PLANT NAME: (1-P)  
Oconee Unit No. 3  
RJL 7/12/77

Amdt. to OL/change to tech specs...notorized 7/5/77...concerning the operation of Oconee Unit No. 3 Cycle 2 with the cycle length extended to 282 EFPD's.....

Re: Oconee Unit 3  
Docket No. 50-287

Figure 3.5.2-1C3

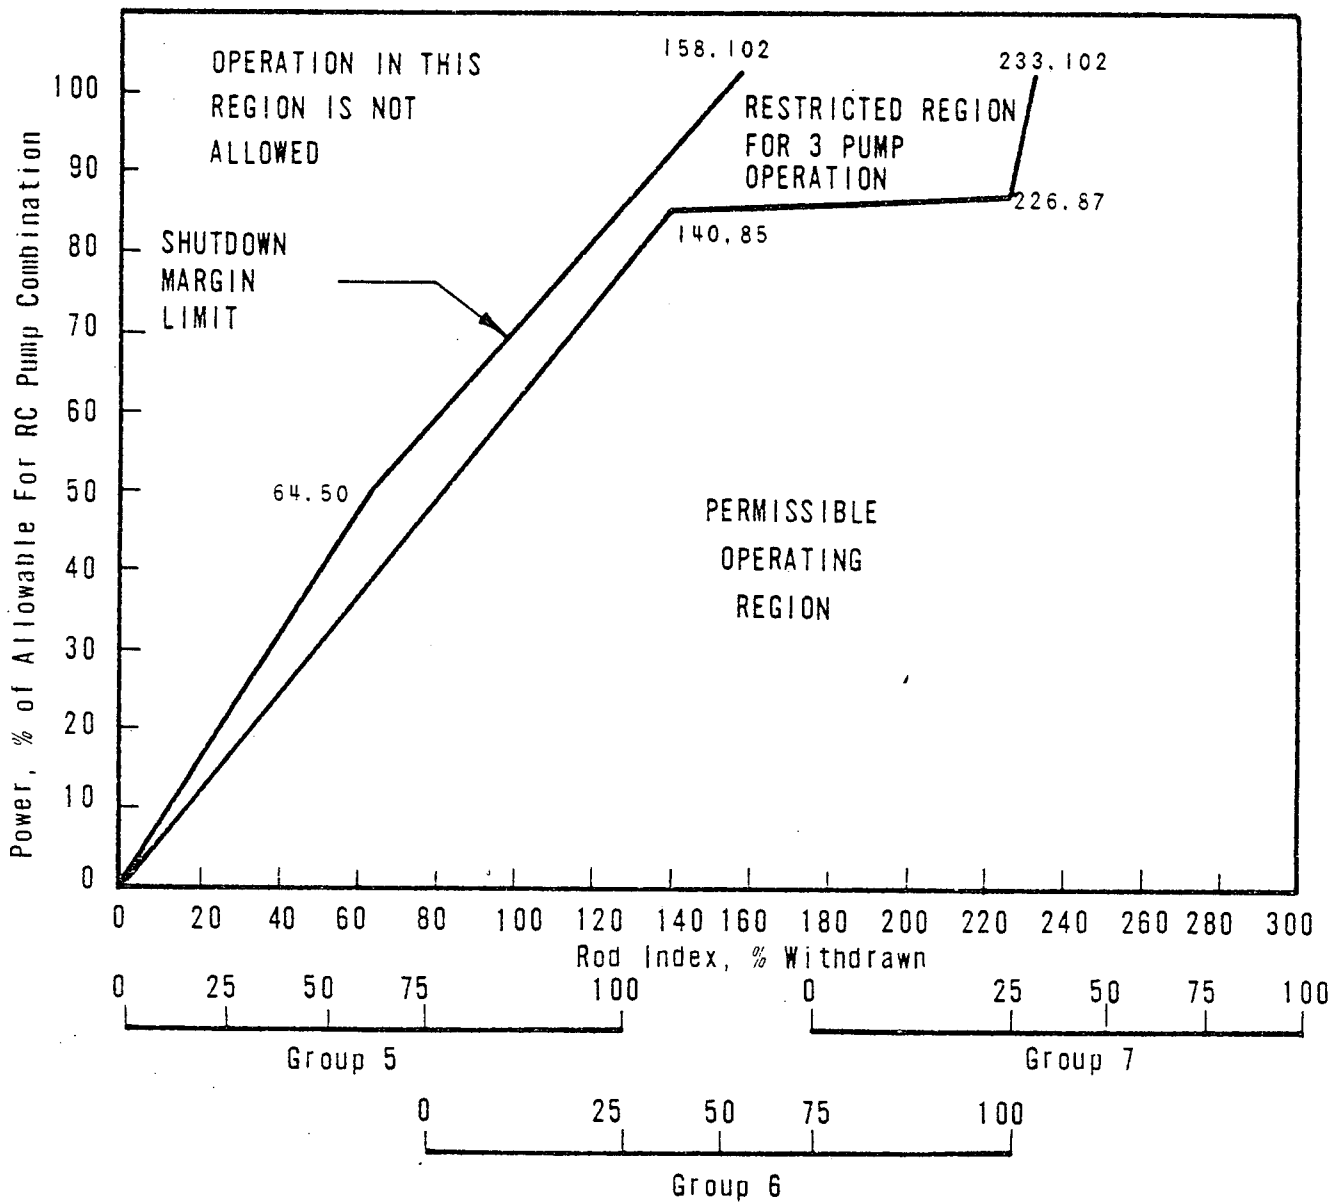
Our letter of July 21, 1976 proposed revisions to the Oconee Nuclear Station Technical Specifications to assure the operation of the Oconee Unit 3 Cycle 2 core within acceptable fuel design and performance criteria for a design cycle length of 265 EFPD's. To provide flexibility in the scheduling of refueling operations at Oconee Nuclear Station, it has become desirable to extend the cycle length of Oconee Unit 3 Cycle 2 from 265 EFPD's to 282 EFPD's. The existing technical specification limits have been reviewed to confirm that they will be valid when the cycle length is extended to 282 EFPD. As a result of this review, it has been determined that the operational control rod position limits (Figures 3.5.2-1C3 and 3.5.2-2C3) power imbalance limits (Figure 3.5.2-3C3) are to be revised as shown in the attachment.

Therefore, to assure that the operation of the Oconee Unit 3 Cycle 2 core will be within acceptable criteria, and pursuant to 10CFR50 §50.90 proposed changes to the Oconee Nuclear Station Technical Specifications are requested which will provide for the operation of Oconee Unit 3 Cycle 2 with the cycle length extended to 282 EFPD's. These revisions are incorporated in the revised figures shown in the attachment.

ROD POSITION LIMITS FOR FOUR-PUMP OPERATION AFTER 226(+10) EFPD Unit 3
